Fire Risk Assessment

Property assessed: B Lister Court Nightingale Avenue
London HA1 3GX

Client: Network Homes Ltd

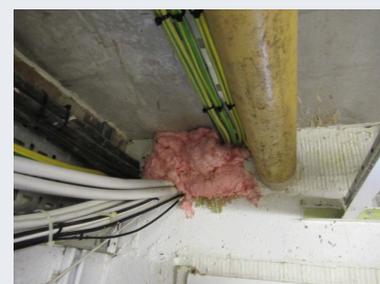
- Known	1			
- Potential	N/A			
Priority	C	Due Date: 30/03/2022	Client Status: Approved	
Question	K.1	<p>Comment: K1 BS9991 - 9.8.1 recommends; The cluster should be lobbied from any staircases serving the building (i.e. a protected lobby should be formed between the cluster front entrance door and the stair door). There is no lobby separating the stairway and cluster entrance doors on the 1st, 2nd and 3rd floors off the stairway from the main block entrance. Lobby protection is provided to the stairs at ground floor level separating the cluster corridor from the stairway. Lobby protection is provided to the alternative rear corner stairway on all levels separating the cluster corridor from the stairway. Bedrooms discharge directly into a protected corridor leading to a protected stairway or stair lobby for ground floor flats. There is one cluster per level with a single direction of travel of 9m from the furthest bedrooms to the lobby. Other cluster bedrooms have a choice of direction to the protected stairway or to the shared interlinked lift lobby of block A. Stairways discharge at ground floor level to the outside and away from the building. Previous recommendation of a C priority not considered suitable so completed and this recommendation with an R priority used.</p>		No image available

Section	Means of Escape			
Action ID	303955			
Quantity		<p>Recommendation: When the buildings are next refurbished the cluster should be lobbied from any staircases serving the building (i.e. a protected lobby should be formed between the cluster front entrance door and the stair door) as recommended by BS 9991 - 9.8.1.</p>

L. Flat Entrance/Residents' Bedroom/Bedsit Doors

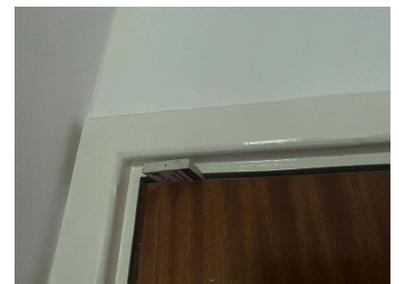
Comment: An excessive gap was noted between the fire door and frame of the fire doorset to bedroom 213. Furthermore, an excessive threshold gap was noted beneath the door to bedroom 318.

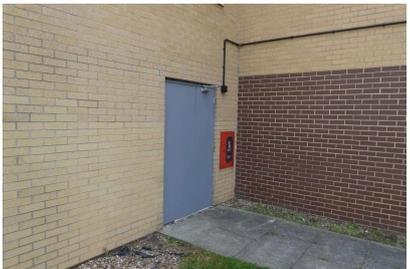
Comment: Other fire safety signs issues noted include:- No fire exit keep clear signage fixed to the exit side of the final exit from the alternative staircase.

Recommendation: Fire exit keep clear signage should be fixed to the exit side of the final exit as noted.
